URBAN DESIGN DIVISION TRANSMITTAL

Site Plan Review #8-90060 Preliminary Plan #1-88153

Project: Cloverleaf Center Germantown

SUBJECT: Site Plan No. 8-90060
Cloverleaf Center Germantown

Intersection Rights-of-Way

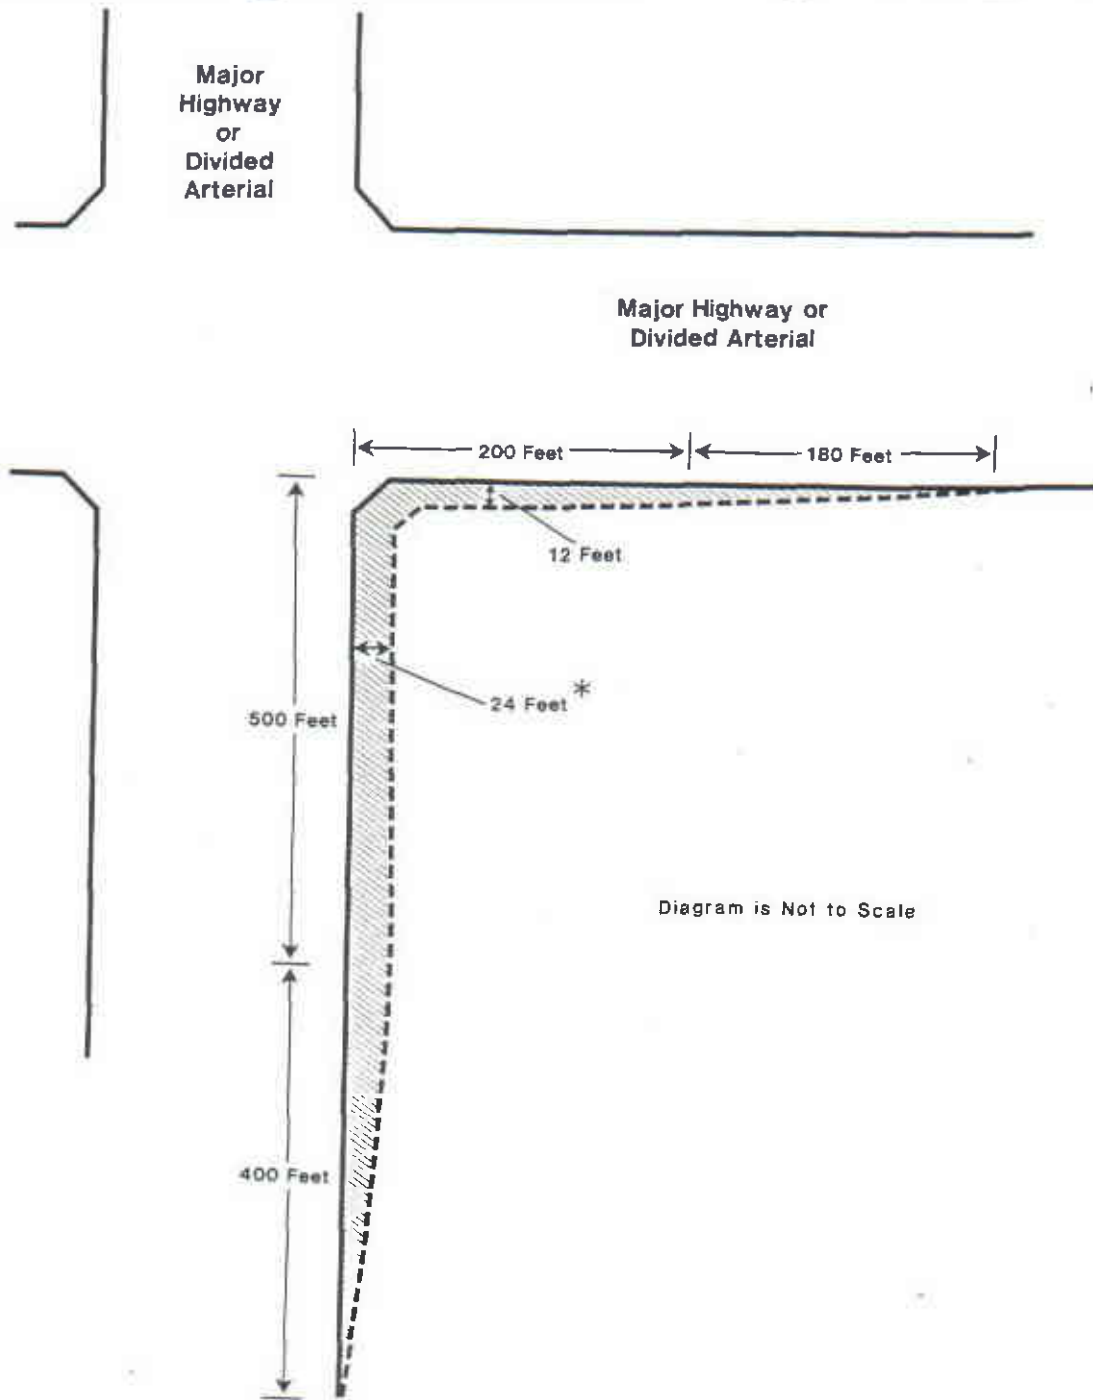
5. Provide additional intersection right-of-way to accommodate turn lanes at the intersection of Crystal Rock Drive and Cloverleaf Drive (see attached diagram).
